APPLICATION NO.		FILING DATE	FIRST NAMED INVENTOR	ATTORNEY DOCKET NO.	CONFIRMATION NO.	
-	10/539,131	06/16/2005	Andreas Wolfert	272982US0PCT	2737	
	22850 ORLON SPIV	22850 7590 07/18/2007 OBLON, SPIVAK, MCCLELLAND, MAIER & NEUSTADT, P.C.			EXAMINER	
	1940 DUKE S'	TREET	PUTTLITZ, KARL J			
	ALEXANDRIA, VA 22314			ART UNIT	PAPER NUMBER	
				1621		
			•			
				NOTIFICATION DATE	DELIVERY MODE	
			·	07/18/2007	ELECTRONIC

Application No.	Applicant(s)					
Office Action Summan	10/539,131	WOLFERT ET AL.					
Office Action Summary	Examiner	Art Unit					
	Karl J. Puttlitz	1621					
The MAILING DATE of this communication appears on the cover sheet with the correspondence address Period for Reply							
A SHORTENED STATUTORY PERIOD FOR REPLY IS SET TO EXPIRE 3 MONTH(S) OR THIRTY (30) DAYS, WHICHEVER IS LONGER, FROM THE MAILING DATE OF THIS COMMUNICATION. - Extensions of time may be available under the provisions of 37 CFR 1.136(a). In no event, however, may a reply be timely filed after SIX (6) MONTHS from the mailing date of this communication. - If NO period for reply is specified above, the maximum statutory period will apply and will expire SIX (6) MONTHS from the mailing date of this comm

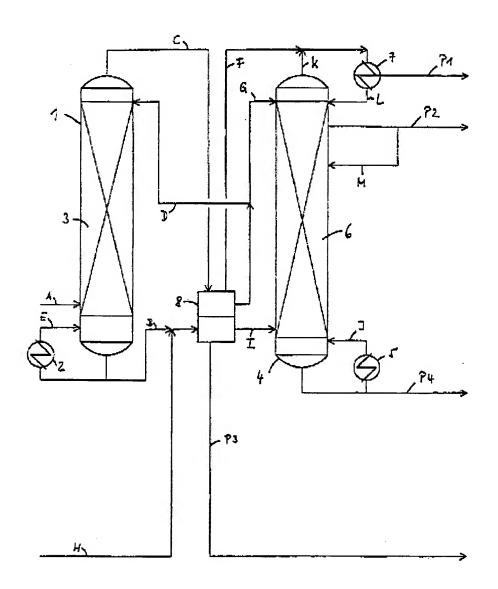
Lokum teaches the instant invention at Example 1, withy reference to the following figure:

wherein a crude reaction mixture, containing 1000 kg/h toluenediisocyanate is completely dephosgenated and the dephosgenated reaction product is mixed with solvent from process sources (i.e. washers, vacuum systems, etc.), and the volatiles recovered from the residue removal to yield a crude distillation feed A with a mass flowrate of 10534 kg/h at a temperature of 149 C., which is in the liquid phase at atmospheric pressure. The crude distillation feed A has the following composition by weight: 10.5% toluenediisocyanate (TDI), 0.2% TDI-residue, 0.006% hydrolyzable chloride compounds (HCC), and a trace amount of low-boilers and noncondensables. with the rest being o-dichlorobenzene. The bottoms products of the upstream distillation column 1 is partially vaporized to generate the vapor stream E and the liquid product B. Stream B has a flowrate of 6298 kg/h which is at a saturation point of 180 C. at 878 mbar. Stream B has a composition by weight of 17.5% TDI, 0.3% residue, 0.01% hydrolyzable chlorides, and the rest being ODB. Stream B is mixed with the bottoms product H from the TDI purification column (not shown) and fed to the vaporizing zone of the interchanger 8. Vapor stream E is fed to the upstream distillation column 1 which has 13 theoretical stages of structured packing 3 in the rectification zone. The upstream distillation column 1 operates at a top pressure of 864 mbar with a pressure drop of 14 mbar. Stream E as well as the reflux stream D effect the necessary fractionation in the upstream distillation column 1. The vapor product C from the upstream distillation column 1 is fed to the condensing zone of the interchanger 8.

In the interchanger 8, the vapor stream C from the upstream distillation column 1 is almost completely condensed and the energy is used to partially vaporize the mixture

of streams B and H. All noncondensibles and uncondensed vapors (stream F) are fed to the condenser 7 of the downstream distillation column 4. Stream F is at 165 C and 864 mbar and has a flowrate of 50 kg/h and a weight composition of 5% inert gases and 95% o-dichlorobenzene. A portion of the condensate is fed as reflux D to the upstream distillation column 1. The remainder of the condensate, stream G is fed to the top stage of the downstream distillation column 4 to effect the removal of phosgene and other lowboilers from the solvent product. G is a saturated liquid at 165.degree. C. and 864 mbar. It has a flowrate of 4233 kg/h and a composition of 10 ppm by weight TDI with between 300 and 400 ppm lowboilers and the rest being o-dichlorobenzene. In this case a reflux ratio of 0.334 is maintained for the upstream distillation column 1 to achieve a TDI concentration in stream G of 10 ppm by weight TDI. The resulting vapor product I from the vaporizing zone of the interchanger 8 is fed to the downstream distillation column 4. the remaining product P3 is fed to the residue removal system (not shown). The product P3 is a saturated liquid at 157 C and 224 mbar. It has a flowrate of 178 kg/h and a weight composition 30.6% o-dichlorobenzene, 10% residue, 0.13% hydrolyzable chlorides, and the rest TDI.

The downstream distillation column 4 is designed with 19 theoretical stages of structured packing. The column operates at a top pressure drop of 205 mbar and a pressure drop over the column of 20 mbar. The vapor stream I from the interchanger, 8 is fed to the downstream distillation column 4 below the packing. In this column, fractionation is performed to achieve a bottoms product P4 that is enriched in TDI, a vapor product P1 enriched in non-condensibles and low-boilers and a solvent product

P2, lean in TDI and low-boiler species. This fractionation is effected by the condenser 7 and the reboiler 5. In the condenser 7, the vapor product K from the downstream distillation column 4 as well as the uncondensed vapor from the condensing zone of the interchanger (stream F) are almost completely condensed, resulting in the vapor stream P1, and the condensate stream L. Stream P1 has a flowrate of 50 kg/h and a composition by weight 20% non-condensibles and 80% o-dichlorobenzene at a temperature of 102 C and a pressure at 205 mbar. Stream L as well as stream G are fed to the top of the downstream distillation column 4. In this example, the downstream distillation column 4 is designed to provide 1 theoretical stripping stage for the separation of low-boilers from the o-dichlorobenzene product P2. The odichlorobenzene product, P2 is removed as a sidedraw product. P2 is a saturated liquid at 125 C and 207 mbar, and has a flowrate of 8811 kg/h. It has a composition by weight of 10 ppm TDI with the rest being o-dichlorobenzene. A reflux ratio of 0.266 is required for the downstream distillation column 4 to reach this product purity. The product P4 is taken from the sump of the downstream distillation column 4 and is fed to an additional distillation column (not shown) for the removal of the remaining solvent and the subsequent purification of the TDI product. Product P4 is a saturated liquid at 155 C and 224 mbar. It has a flowrate of 1676 kg/h and a composition by weight of 32.4% odichlorobenzene, 0.09% hydrolyzable chlorine, and the rest being TDI.

The difference between the process set forth in Lokum and the process covered in the rejected claims is that Lokum fails to teach the particular evaporators, interchangersn columns and dryers required by the claims. However, Lokum suggests
